To: Delaware Avenue Hamlet Enhancement Study Advisory Committee  
Study Advisory Committee Meeting #5 – June 8, 2010  
From: Margaret Irwin, River Street Planning  
Date: June 15, 2010  
Re: Meeting Minutes for SAC Meeting #5

**Transportation Improvement Plan - Document Review**

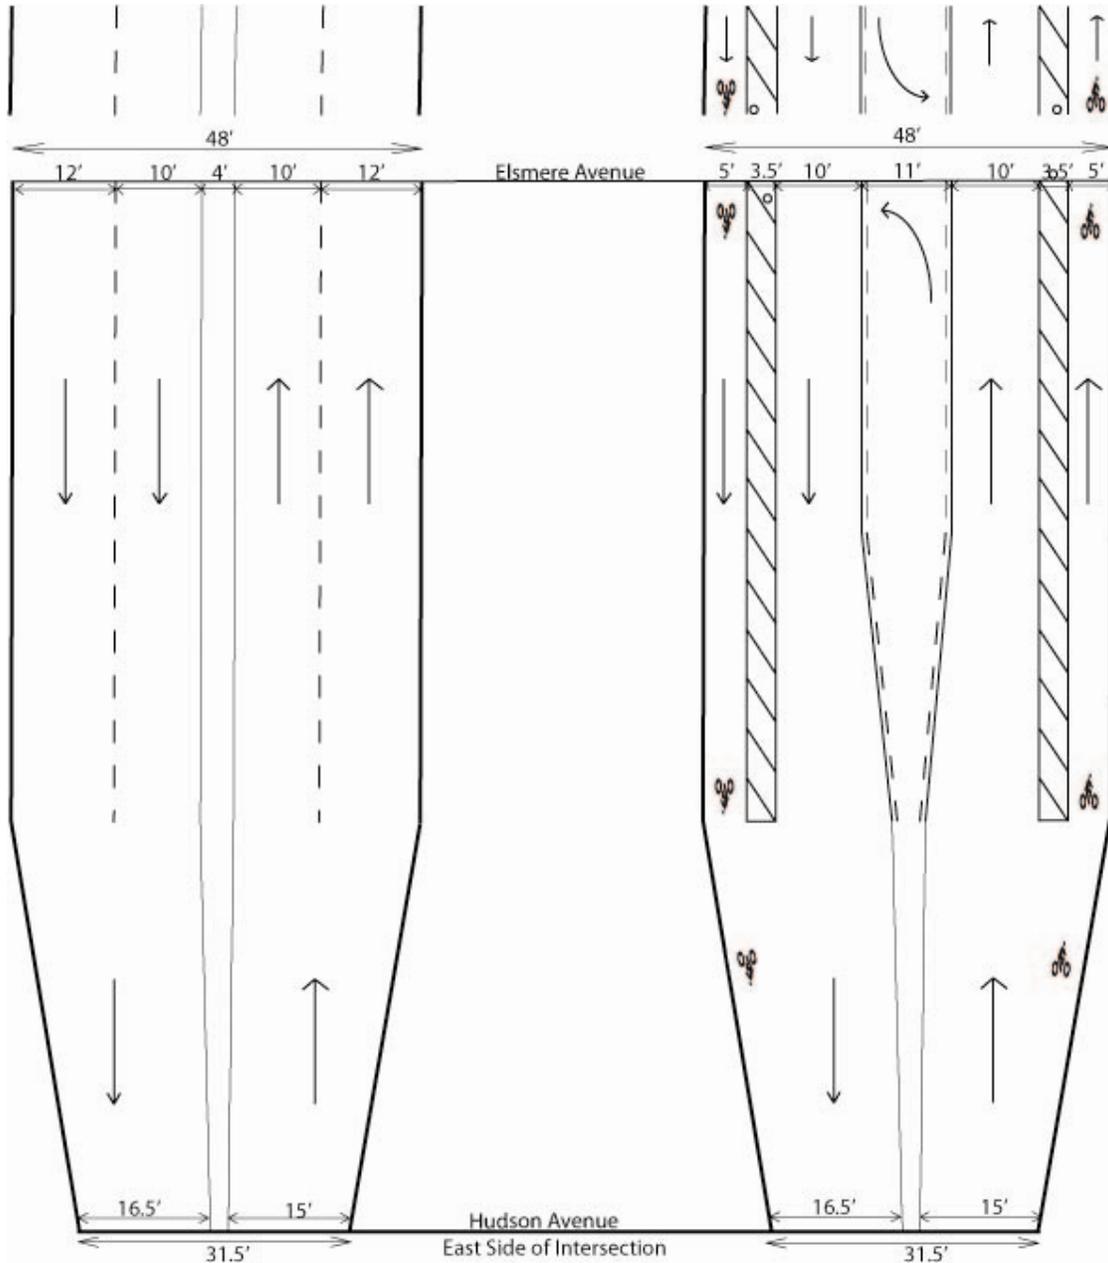
1. Page 8- The Town should plan to engage or attend the Business Forum with Chamber to share and discuss the vision statement. Consider revising the statement to include the phrase “viable businesses” as part of the statement.
2. Page 14 - Correct missing number in item 3.
3. Page 16 – What can be done to increase enforcement of pedestrian laws? There should be more community education. Following the meeting Bob talked to the

- c. The SAC discussed lack of enforcement to protect pedestrians in crosswalks. Can the Town post signs saying what the fine is if you get a ticket as a deterrent? Can someone talk to Chief of Police? Increase fees? Conclusion is that more enforcement would make a big difference. (See above and attached regulations)

Deputy Police Chief regarding fines/points for failure for driver to yield to pedestrians in crosswalks, and he provided the following information (see email

Section 1151(a) applies to vehicles yielding to pedestrians within a crosswalk.
